## Product change notification (PCN)

| <b>Title / short description</b>   | Integration of a Lanyard Ring and Packaging Adjustment |
| <b>Change number</b>               | CBH260027-00                                           |

# **Product Change CBH260027 / UNIFOX-CT 4,8P 1212609**

## Product Change Cable Tie Tool

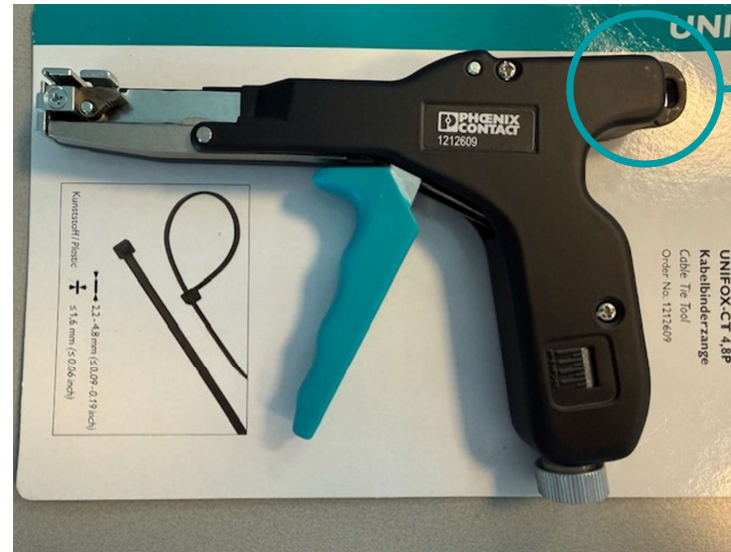
- Integration of a lanyard ring
- Improved work safety by preventing tool drops
- No change to core function
- Small change in geometry in the area of the ring
- Packaging updated
